Technical Bulletin

Product Line: Bambi

Models: BBX4453, BBX5566, BBX6578, BBX7590

Subject: Actuator Cable Guard

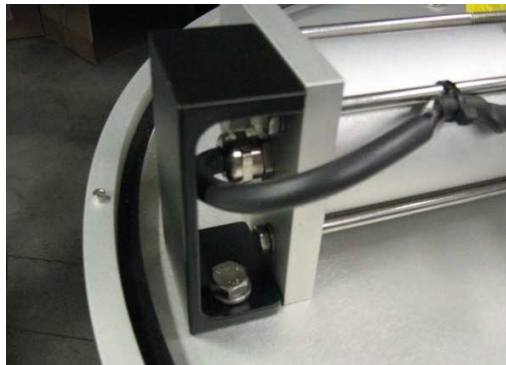
There have been multiple failures of Bambi MAX IVC's and actuators on the 25" valve. Investigation into the failures has identified the problem as damage to the electrical cable at the point it enters into the actuator. Water then enters the cable and migrates into the actuator and IVC causing a failure. The damage to the electrical cable is being caused by the IDS restrainer cable during deployment. In one case, the cable gland was torn off.

A cable guard has been added to protect the electrical cable and gland from damage. The guard mounts to the top plate of the valve using an existing bolt hole. The guard can be retrofitted in the field.
